PROJECT: SUPPLY AND DELIVERY OF LABOR AND MATERIALS FOR THE REPAIR/RENOVATION OF THE CED BUILDING

OWNER: Industrial Technology Development Institute (ITDI)

SUBJECT: BID BULLETIN NO. 1

Date: October 22, 2019

SHEET CONTENTS:
DETAILS; EXISTING PANEL
SCHEDULE; PART OF
EXISTING ONE-LINE DIAGRAM

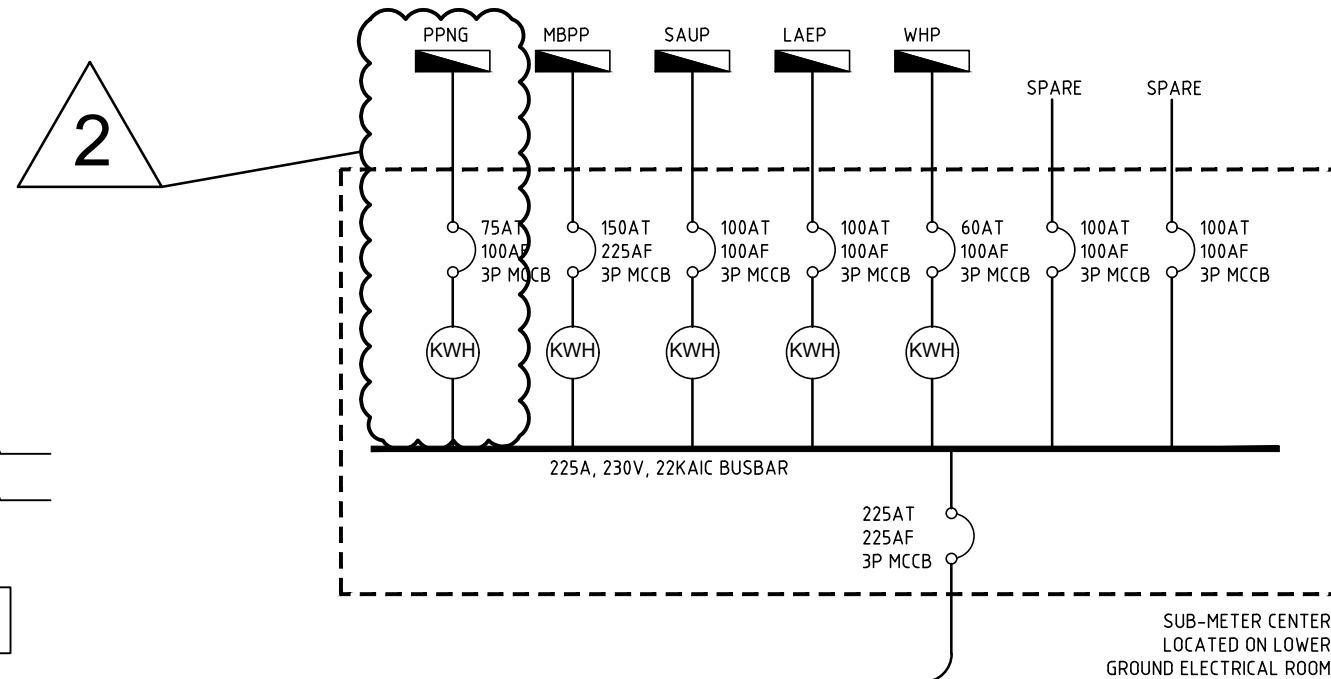
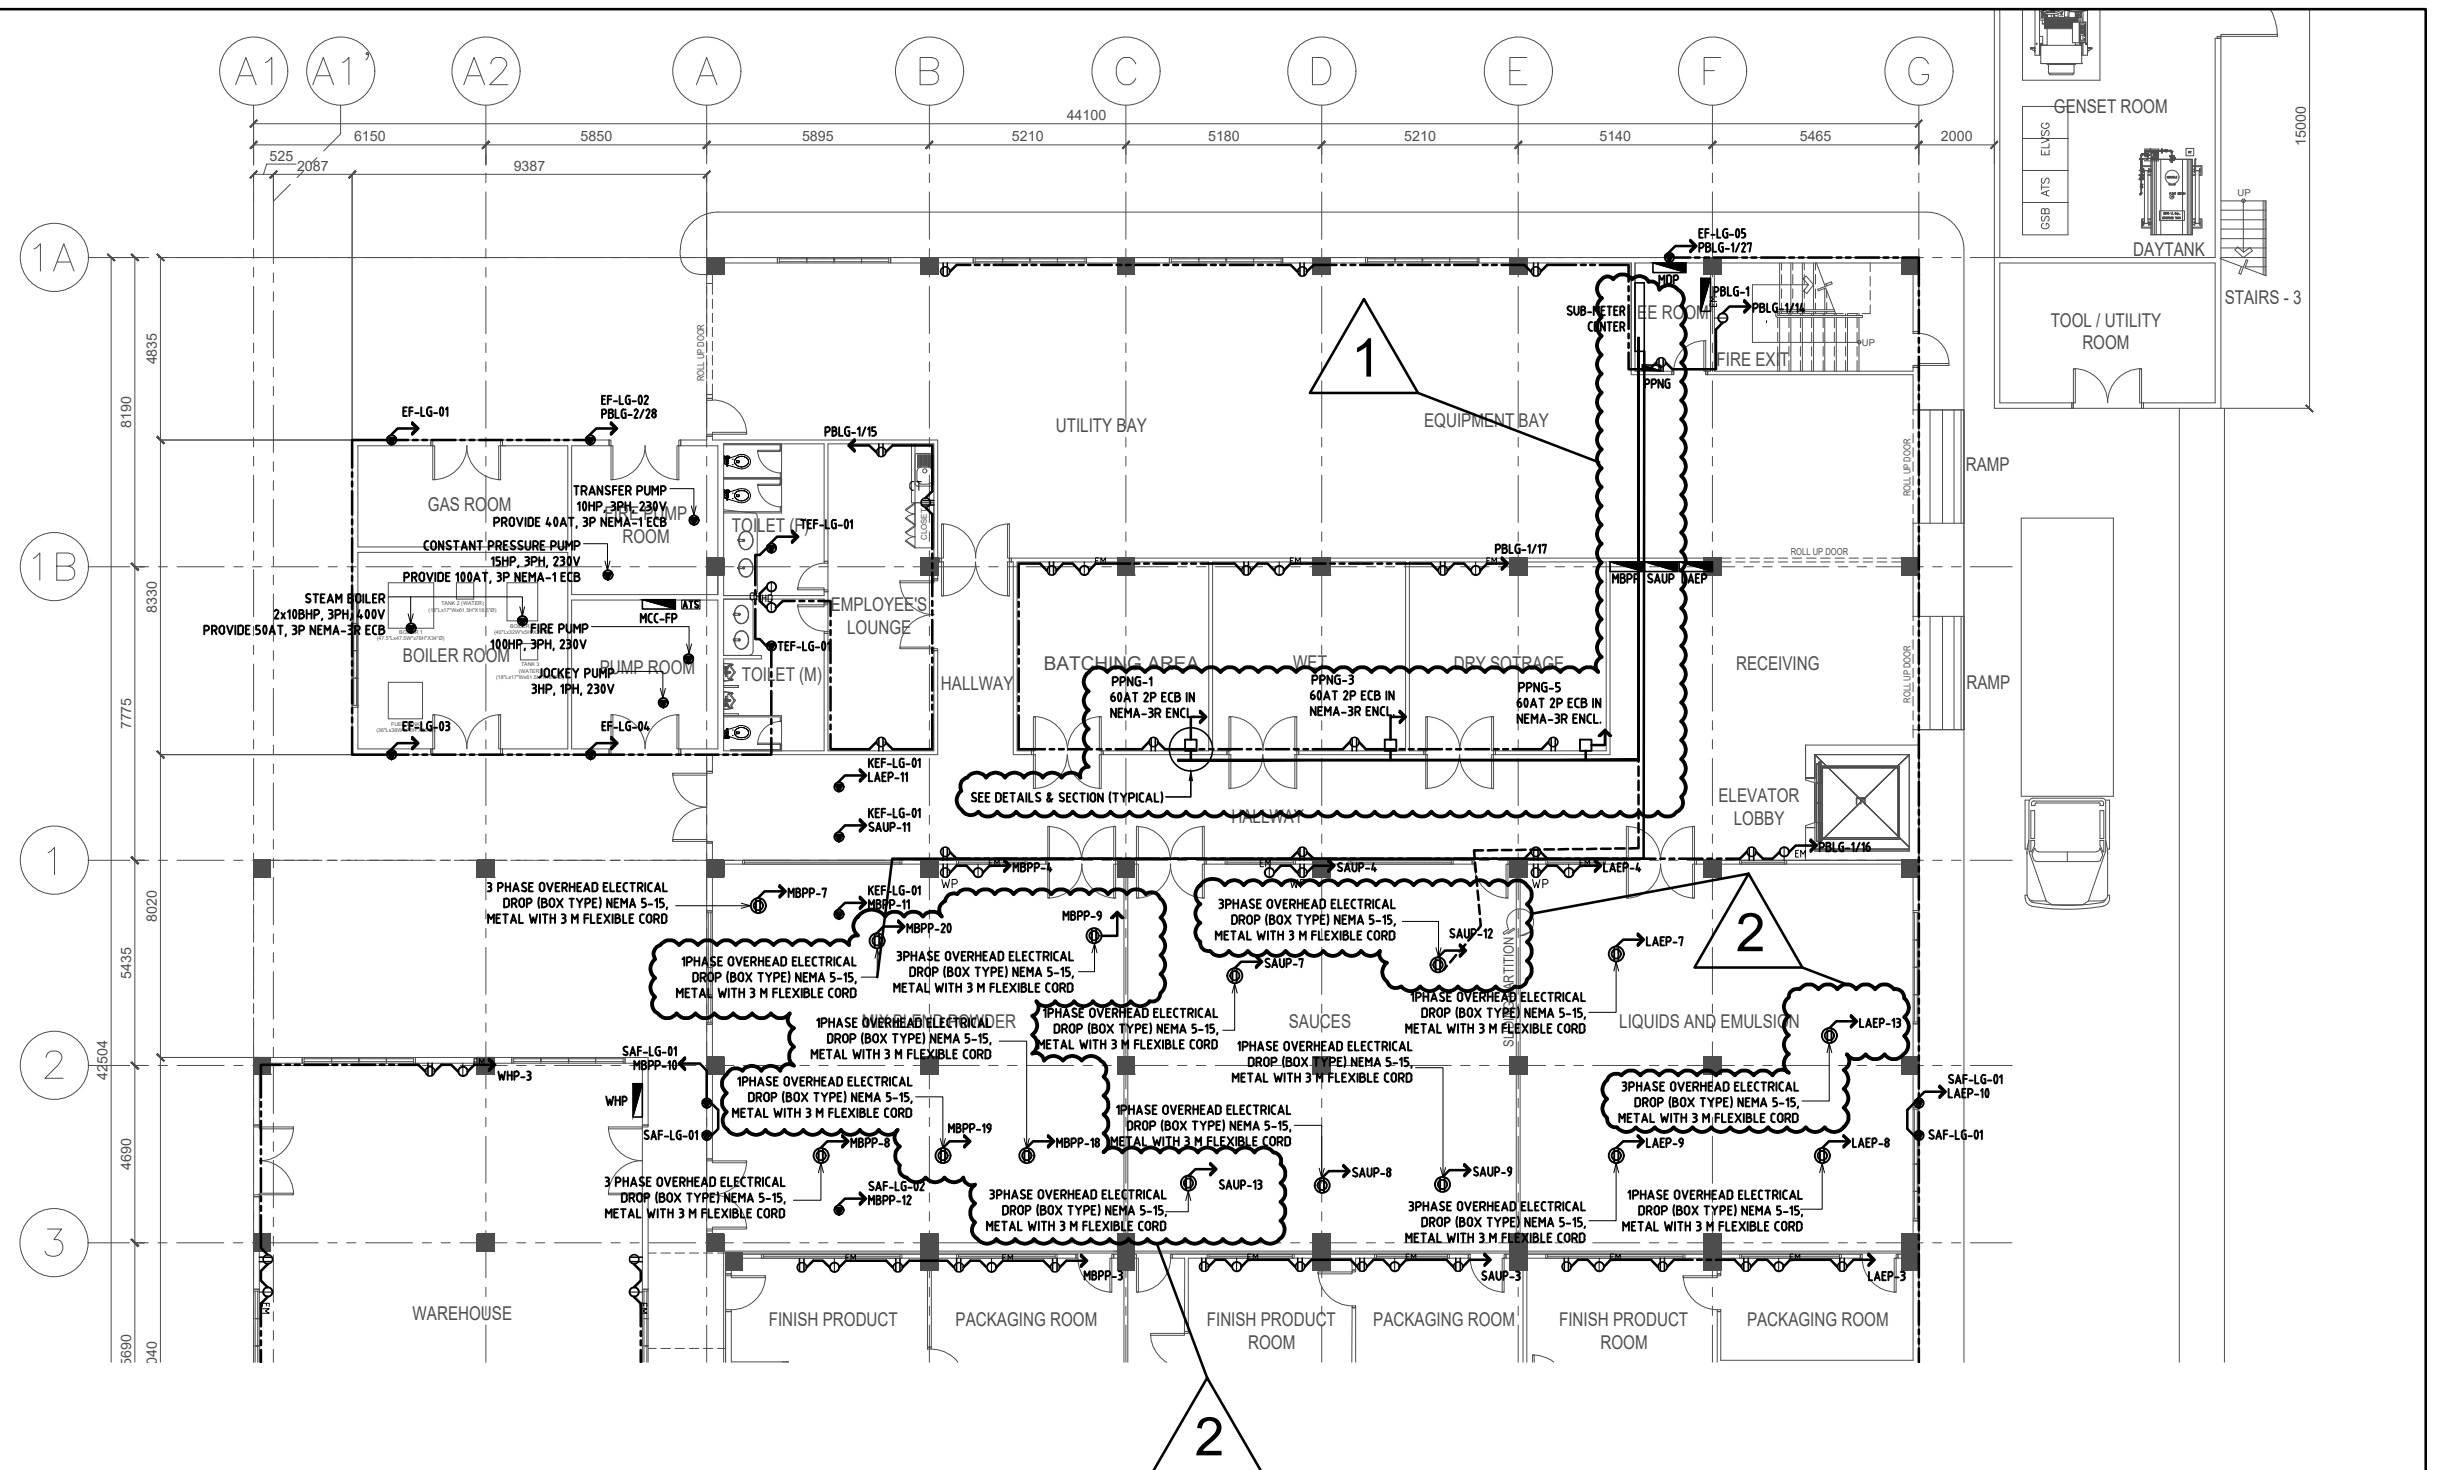
2 ADDED PANEL "PPNG" and KWH-METER

UPGRADING OF LOWER GROUND FLOOR EQUIPMENTS POWER LAYOUT

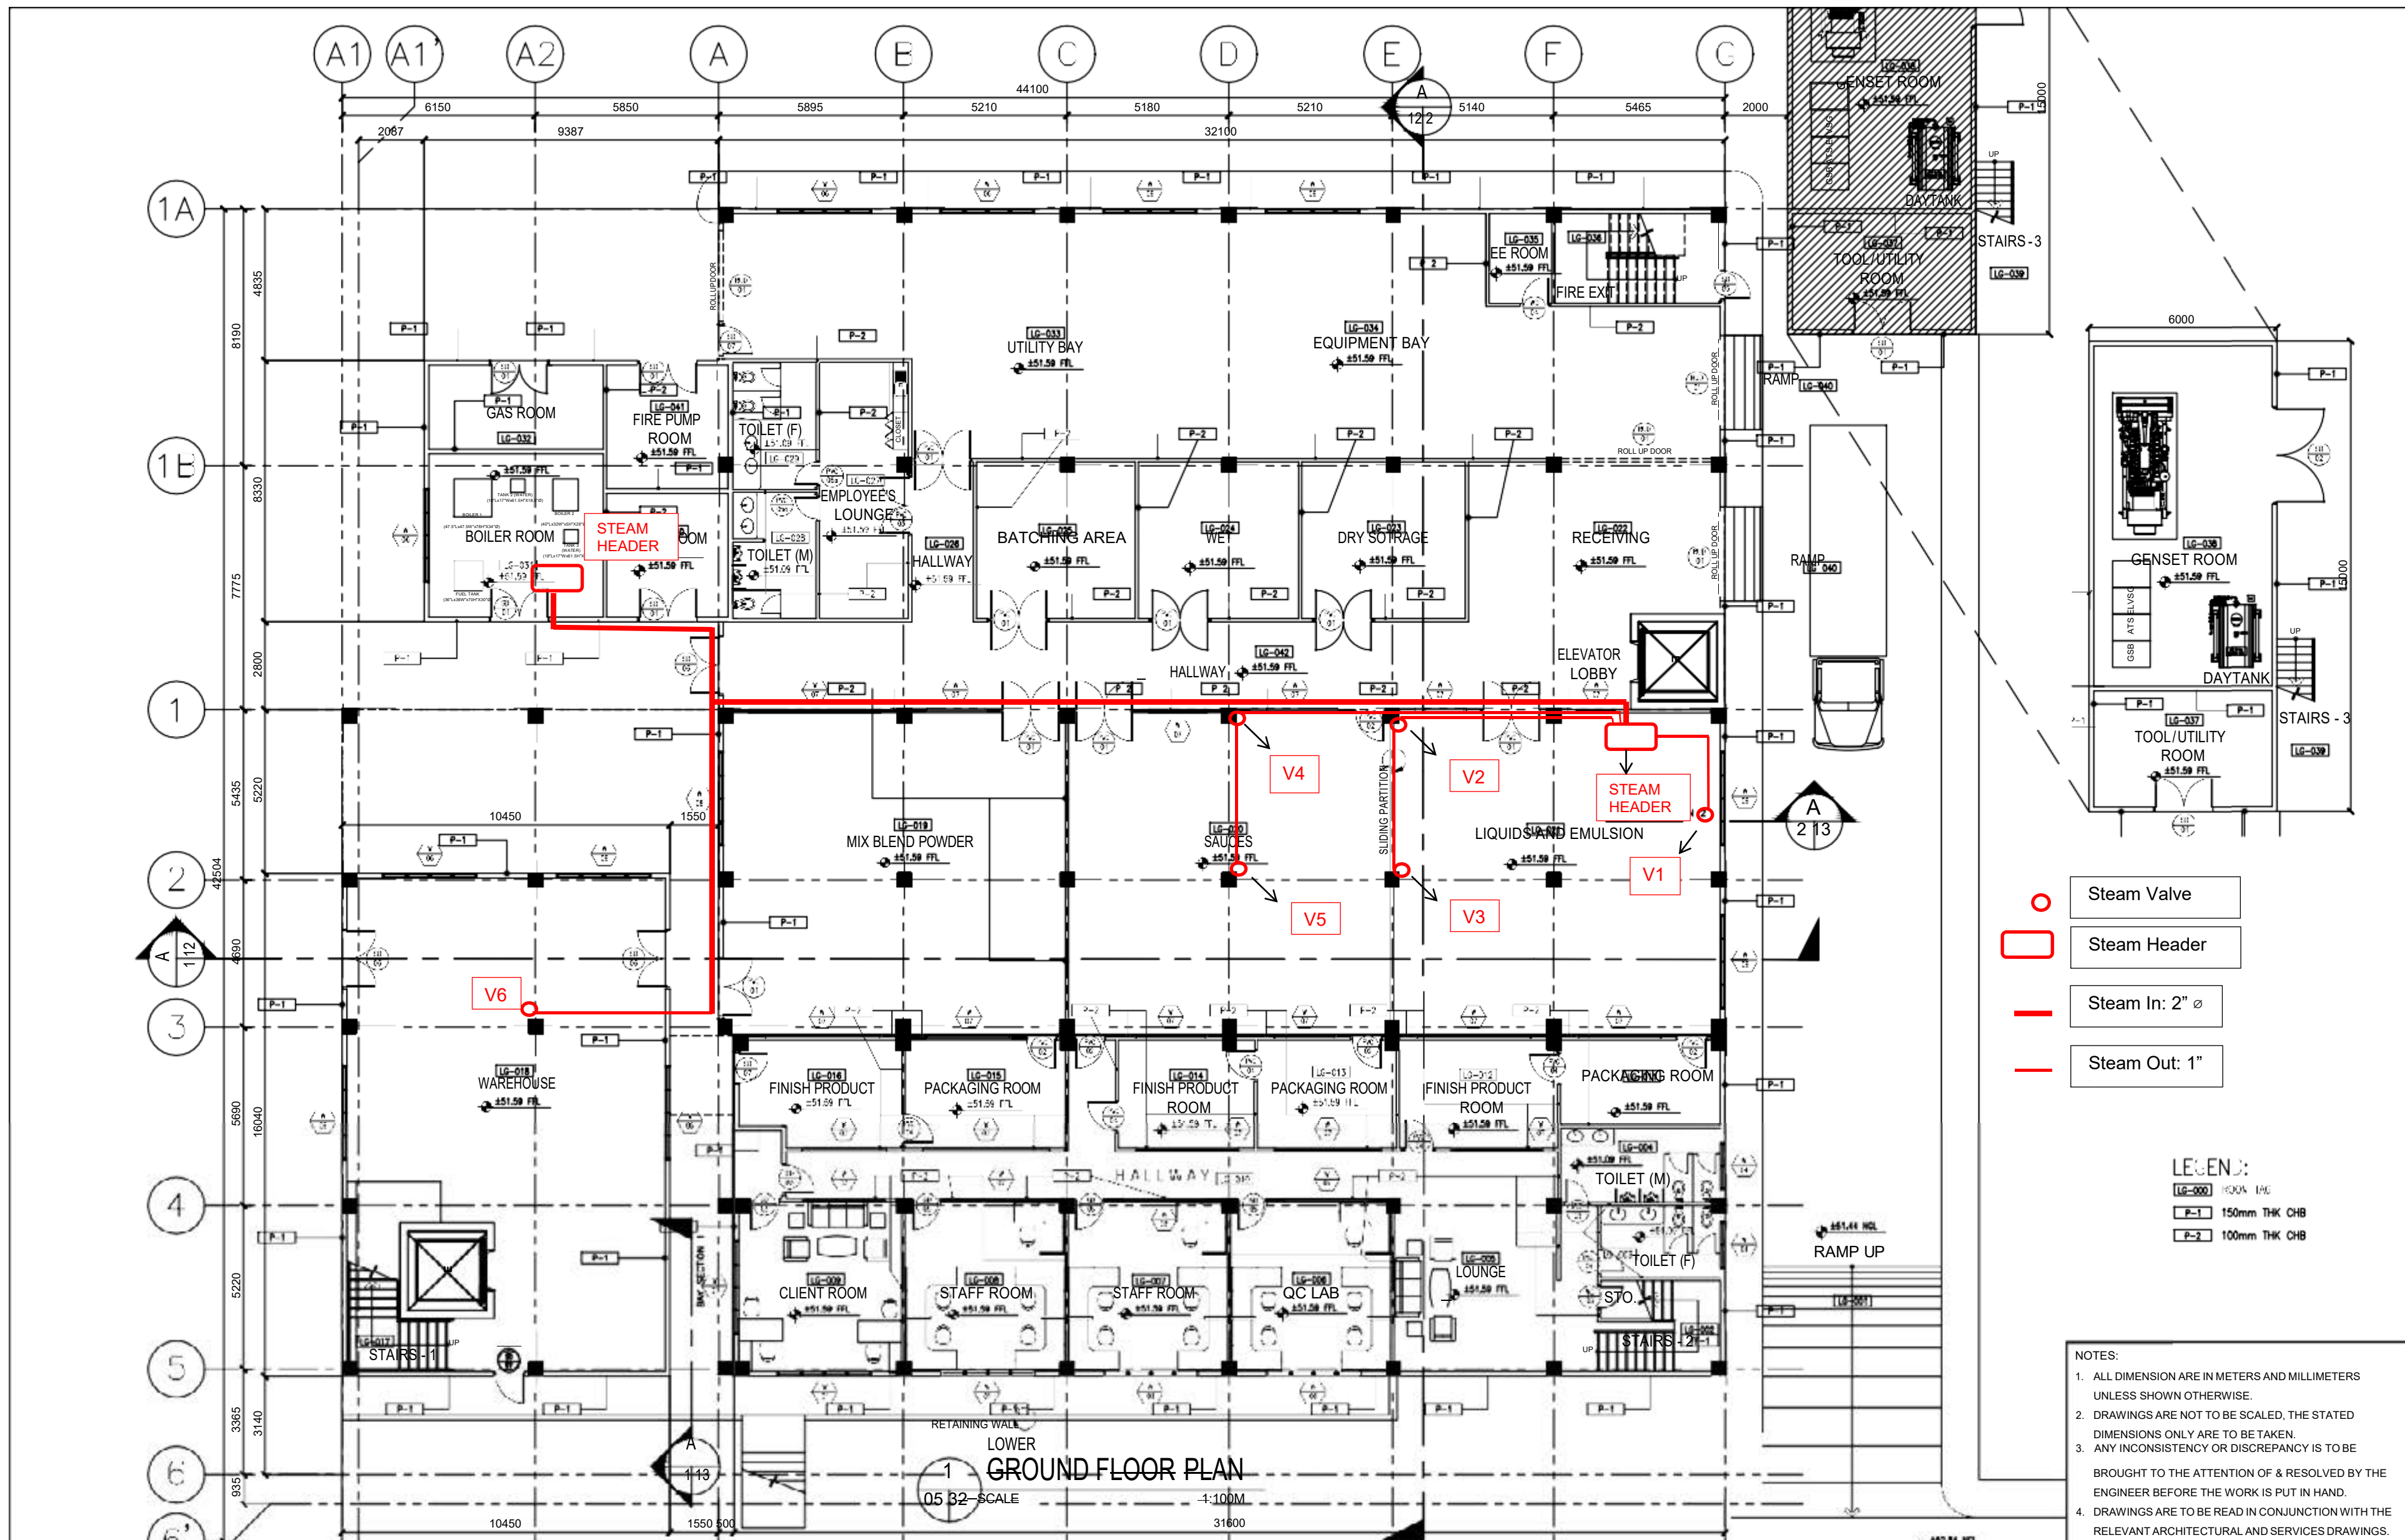
- 1. ADDED 60AT 2P ECB FOR HIGHER RATING EQUIPMENT/S
- 2. ADDED PANEL "PPNG"
- 3. ADDED CABLE TRAY
- 4. ADDED OVERHEAD ELECTRICAL DROP FOR EQUIPMENTS PROVISION
- 5. REVISED CIRCUIT DESIGNATION AND ADDED INFORMATION DETAILS
